# INSTRUCTION TO SERVICE

ITS-60660		March 4, 2023
<b>SECTION:</b>	549-HVAC SYSTEM	
<b>WRITTEN BY:</b>	Mark Reitz	
<b>SUBJECT:</b>	Hose clamp replacement for Eberspaecher auxiliary heater fuel supply lines.	
<b>ISSUE:</b>	Coach auxiliary heater installations have been found with the incorrect size hose clamps on the fuel supply lines.	
<b>SUMMARY:</b>	Performing this procedure will ensure the proper fuel line clamps are being used.

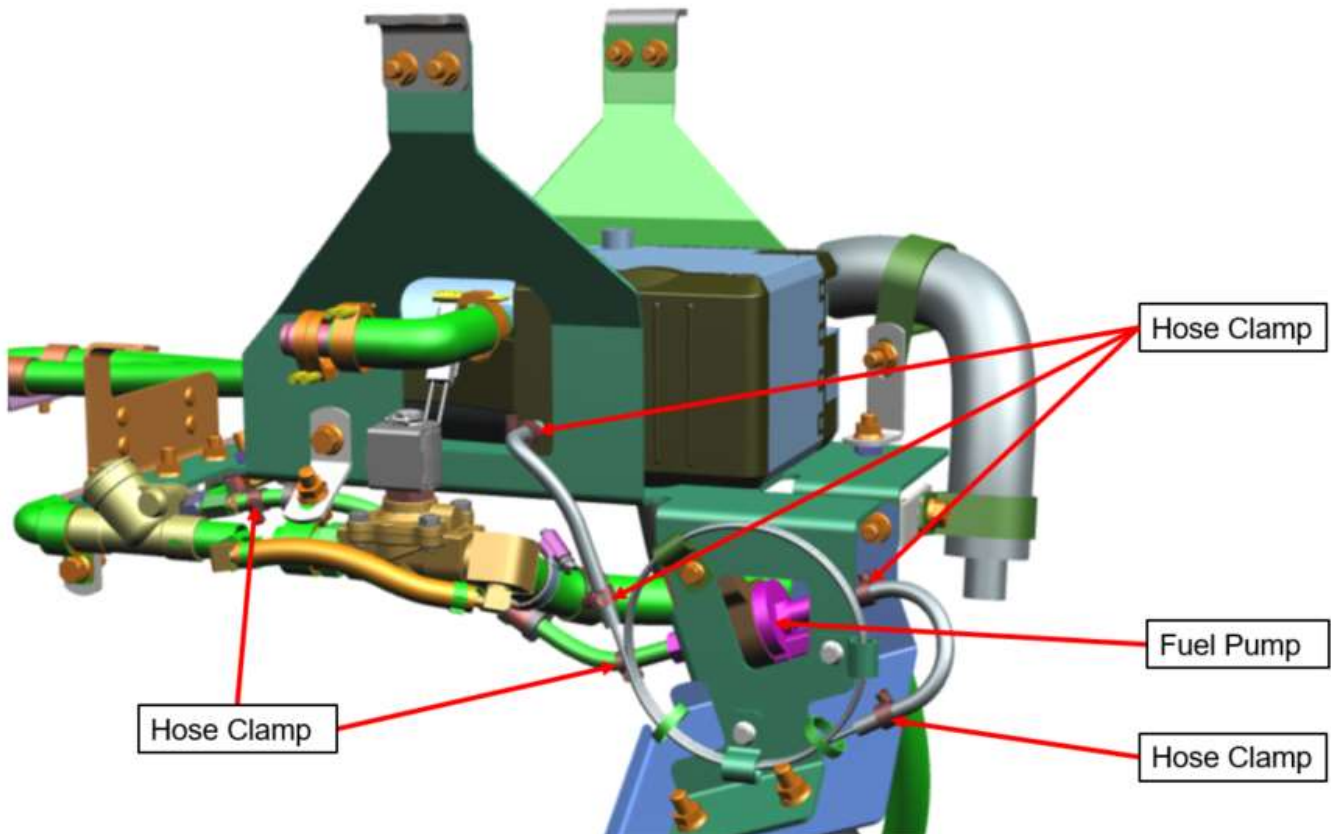
1. Set park brake and chock wheels.
2. Turn the main battery disconnect switch to the "OFF" position.
3. Ensure the engine has cooled down to room temperature.
4. Locate the six (6) hose clamps attached to the auxiliary heater fuel supply hoses. Remove and discard existing clamps.
5. Install new hose clamp, PN 8410272, at all six (6) locations. Torque hose clamps to 12-14 IN-LBS.
